BioTechnica International, Inc.

February 26, 1985

RE: Materials License #20-20506-01

Request for an Amendment to Materials License #20-20506-01

P-III,C. An enlargement of the architectural plan for the Phase III radioisotope laboratory.

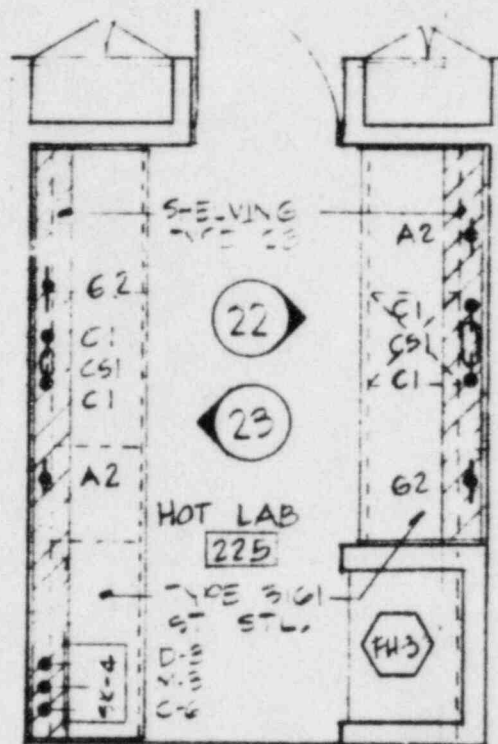
The radioisotope room or "hot" lab is located at the far end of the main corridor, intentionally removed from heavy traffic areas (See Fig. P-III,A, highlighted in yellow). Figure P-III,C illustrates the design and safety features in this lab which are identical to that described for the Phase I and II hot labs (Reference Section 13, pp. 3-4 of 1981 application; Section A, pp. 3-4 of 1983 amendment). Bench tops are stainless steel with spill-containing lips. The sink is stainless steel with foot-operated faucets. The floor consists of a sealed, impermeant molded covering and the walls will be painted with impermeant paint. The safety hood in this room is a stainless steel topped, four-foot wide chemical fume hood with an individual charcoal filtered exhaust (identical to the safety hood in Phase II). Although Phosphorus-32 is the primary radioisotope to be used in this hot room, Sulfur-35,

Hydrogen-3, Carbon-14, and low levels of Iodine-125 may also be handled. All work with high levels of Iodine-125 will remain on the first floor in the Phase I hot room which is currently used for Iodine-125 work.
